TECHNICAL BULLETIN

MODIFICATION/REPAIR OF ROOF RIB BRACKET

Bulletin Completed Record Technical Bulletin TB900-033R1, MODIFICATION OF ROOF RIB BRACKET

Figure 1. Upper Fuselage

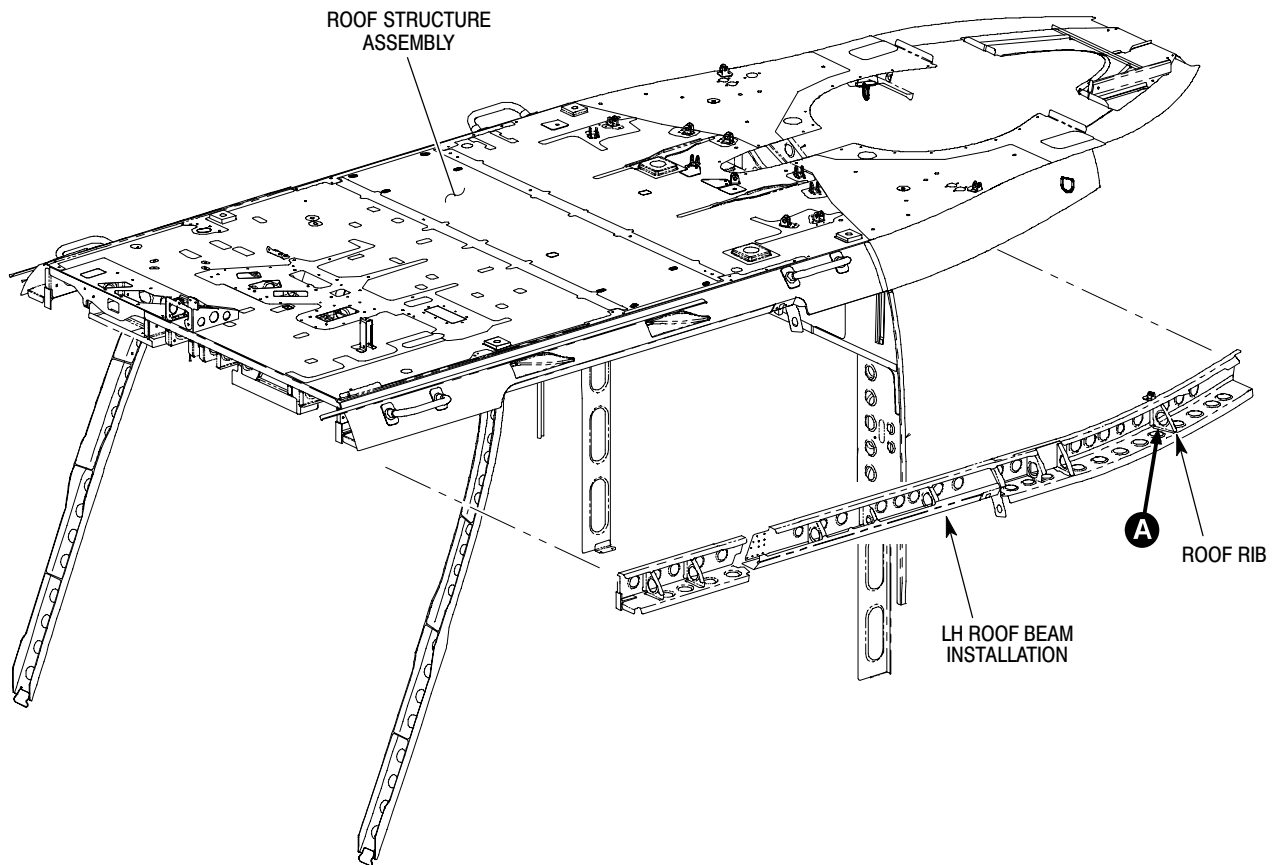
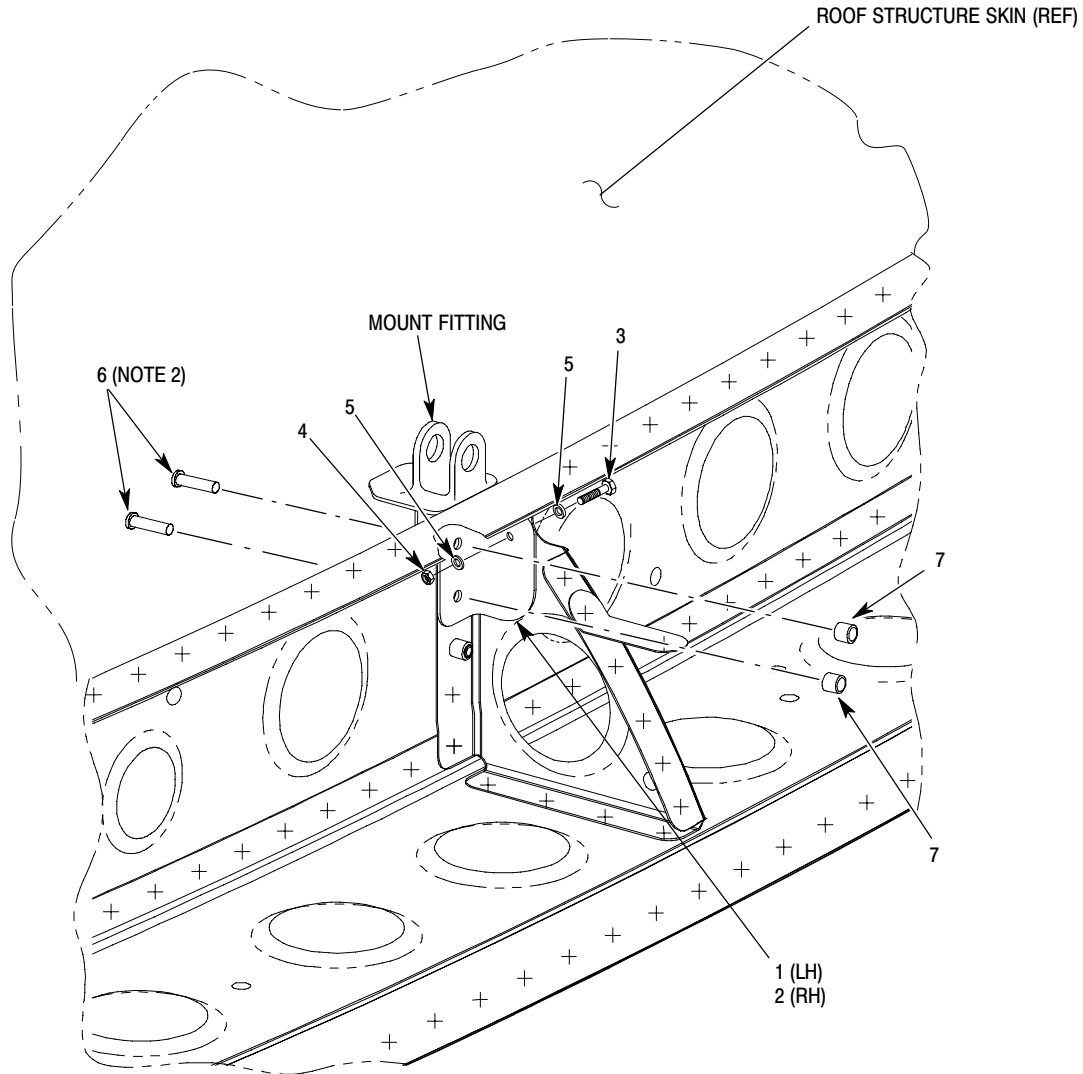
A. Prepare Aircraft

(Ref. Figure 1 and Figure 2)

- (1). Remove cargo compartment linings and panels to access the roof beam installation structure. (Ref. CSP-900RMM-2)
- (2). Remove additional equipment as necessary for more access. (Ref. CSP-900RMM-2.)
